SAFETY EVALUATION BY THE OFFICE OF NUCLEAR REACTOR REGULATION
RELAXATION REQUEST FROM ORDER EA-03-009 REGARDING THE
CONTROL ELEMENT DRIVE MECHANISM EXAMINATION
FACILITY OPERATING LICENSE NO. NPF-6
ENTERGY OPERATIONS, INC.
ARKANSAS NUCLEAR ONE, UNIT 2
DOCKET NO. 50-368

Figure 1

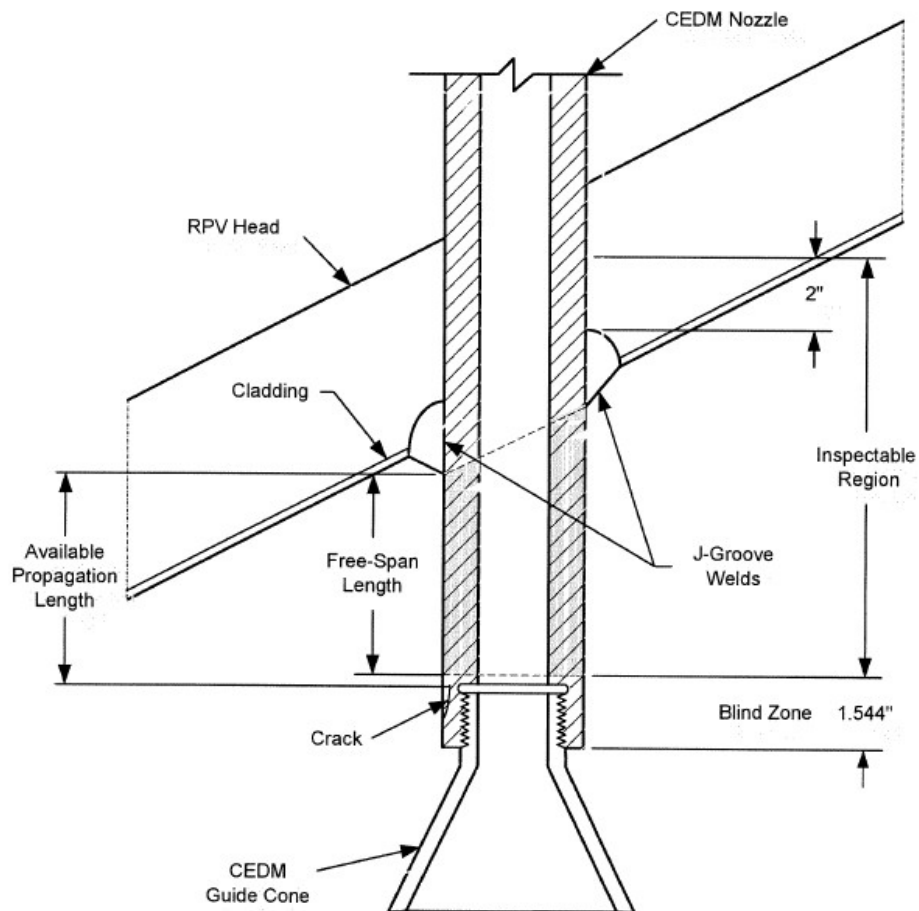
The licensee states that the inside diameter (ID) surface of each CEDM nozzle (i.e., nozzle base material) shall be ultrasonically examined from two (2) inches above the J-weld to 1.544 inches above the bottom of the nozzle. The licensee states that it will also perform an assessment to determine if leakage has occurred into the interference fit zone, as currently specified in Section IV.C.(1)(b)(i) of the Order. Figure 1 from the licensee's August 27, 2003, submittal shows the inspection areas of a CEDM nozzle as defined by the licensee.

The licensee states that meaningful UT data cannot be collected in the threaded area or the chamfer region, since the chamfer region geometry causes sporadic signals. The licensee further states that, once the guide cone is reached, sound cannot pass into the CEDM nozzle base material because of the gap that exists between the guide cone and the nozzle at the threaded connection. This leaves a length of 1.344 inches ($1.25 + 0.094$) at the bottom of the CEDM nozzle that cannot be inspected by UT examination due to nozzle configuration.

only collects data down to a point 0.200 inch above the chamfer. This makes the total distance at the bottom of the nozzle that cannot be UT inspected equal to 1.544 inches (1.25 in threads + 0.094 inch chamfer + 0.2 inch). The licensee refers to this area as the "blind zone" and states that it knows of no UT equipment currently available that resolves the blind zone limitation, and, therefore, new UT equipment would have to be developed and appropriately qualified. The licensee also states that the time and resources required to develop this equipment are unknown.

The staff finds that the licensee's proposed alternative examination of the CEDM RPV head penetration nozzles using UT from 2 inches above the J-groove weld to 1.544 inches above the bottom of the CEDM nozzles, and the augmented examination of nozzles without sufficient free-span length, provide reasonable assurance of the structural integrity of the RPV head, VHP nozzles, and welds. Further inspection of the CEDM nozzles in accordance with Section IV.C.(1)(b)(i) of Order EA-03-009 would result in hardship without a compensating increase in the level of quality and safety. Therefore, pursuant to Section IV, Paragraph F, of Order EA-03-009, good cause has been shown for relaxation of the Order, and the staff authorizes, for one operating cycle commencing with the startup from the Fall 2003 refueling outage, the proposed alternative inspection for all CEDM head penetration nozzles at ANO-2, subject to the following condition:
